STAFF RECOMMENDATION
1309 Woodland Street
June 17, 2015

Application: New construction—outbuilding; Setback determination
District: Lockeland Springs-East End Neighborhood Conservation Zoning Overlay
Council District: 06
Map and Parcel Number: 08309015600
Applicant: David Baird, Architect
Project Lead: Melissa Baldock, melissa.baldock@nashville.gov

<p>Description of Project: Application is to construct an outbuilding (not a detached accessory dwelling unit). The outbuilding requires a reduction to the rear setback.</p> <p>Recommendation Summary: Staff recommends approval of the project with the following conditions:</p> <ol style="list-style-type: none"> 1. Staff approve the final details, dimensions and materials of windows and doors prior to purchase and installation; and, 2. Staff approve the roof color, dimensions and texture. <p>With these conditions, staff finds that the project meets Section II.B. of the <i>Lockeland Springs-East End Neighborhood Conservation Zoning Overlay: Handbook and Design Guidelines</i>.</p>	<p>Attachments</p> <p>A: Photographs B: DADU and Outbuilding Worksheet C: Site Plan D: Elevations</p>
---	--

Date: 5.29.2015
3D PERSPECTIVE VIEWS

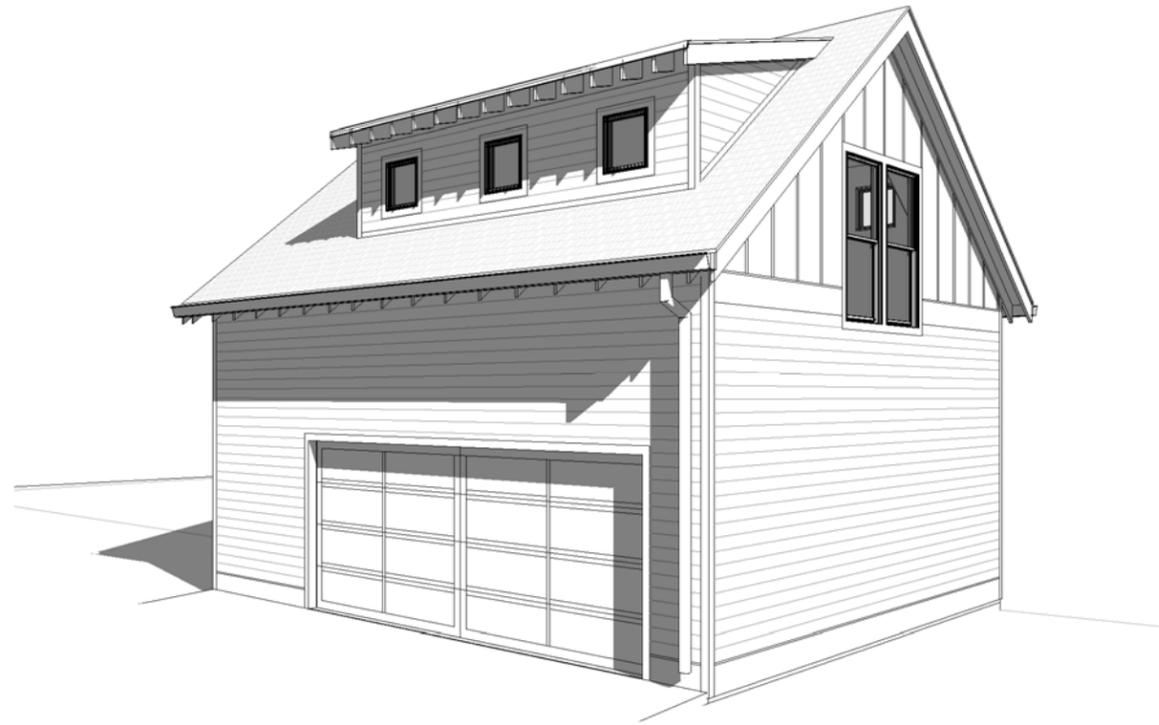
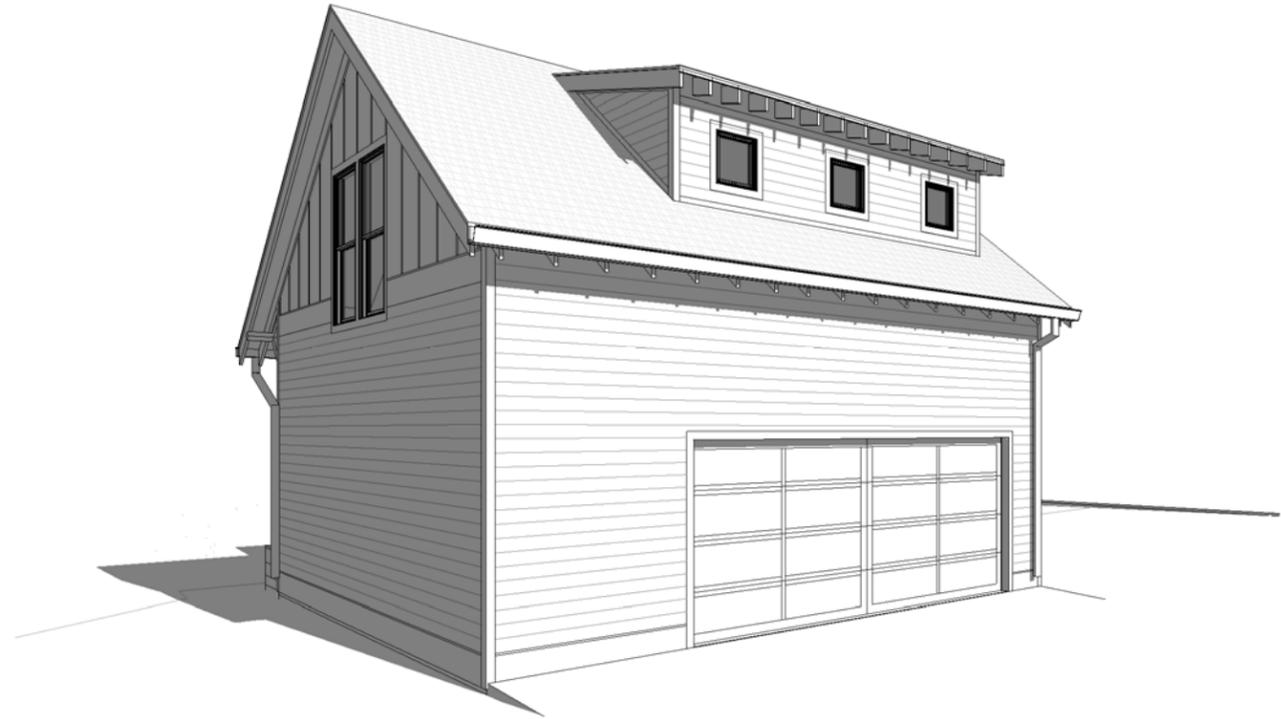
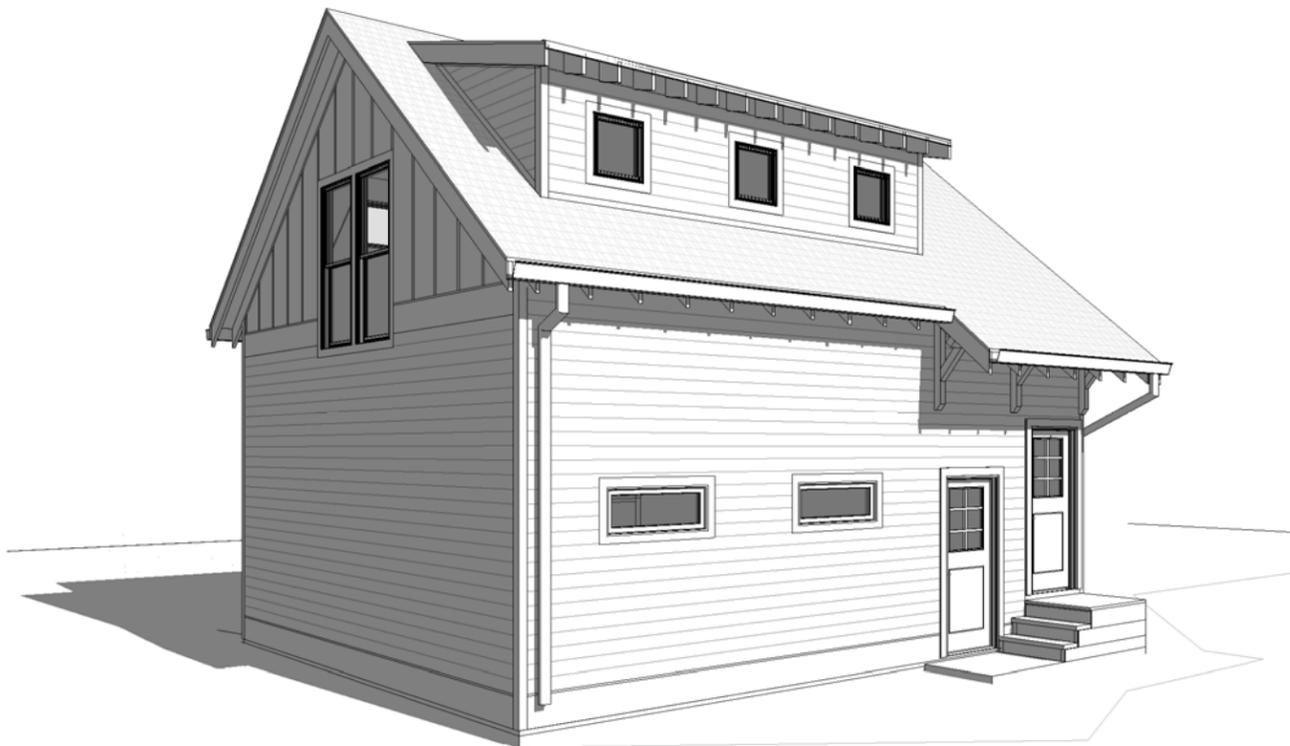
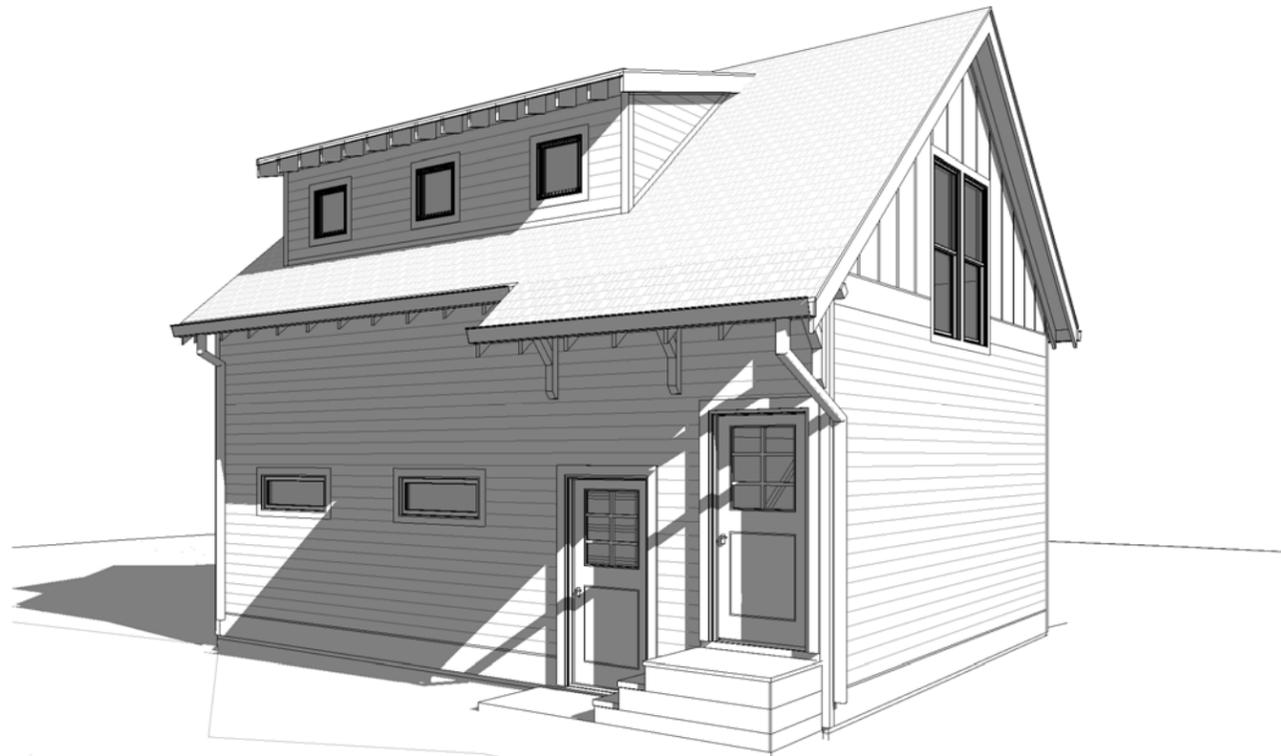
The proposed outbuilding requires a reduction to the rear setback. Base zoning requires that the outbuilding be ten feet (10’) from the rear property line. The applicant is proposing to situate the building five feet (5’) from the property line. Historically, outbuildings were located close to, or on the rear property line. An analysis of the immediate area shows that there are several outbuildings that sit closer than five feet (5’) from the rear property line. Staff therefore finds that the setback determination meets the design guidelines.

The outbuilding will be accessed via the alley and will have a footprint of six hundred and sixteen square feet (616 sq. ft.). Its eave height will vary between eleven feet, six inches (11’6”) and thirteen feet (13’). Staff finds the eave height to be appropriate since the eaves will be no taller than the historic house’s eaves, and the structure will not be used as a detached accessory dwelling unit. The ridge height will be twenty-three feet, eight inches (23’8”), several feet lower than the ridge of the historic house.

The proposed outbuilding has dormers that are set off the ridge and are set back two feet (2’) from the wall below. The dormers are eighteen feet (18’) in width, which is approximately sixty-four percent (64%) of the roofscape. Since the outbuilding is not a detached accessory dwelling unit, staff finds the size of the dormers to be appropriate.

The proposed materials are five inch (5”) fiber cement lap siding, fiber cement board and batten, fiber cement trim, wood windows, wood stairs, wood pedestrian doors, insulated steel vehicular doors, wood brackets, and asphalt shingle roof. The foundation will be a concrete slab. Staff asks to approve all windows and doors and the shingle color prior to purchase and installation of these materials.

1. Staff approve the final details, dimensions and materials of windows and doors prior to purchase and installation; and,
2. Staff approve the roof color, dimensions and texture.
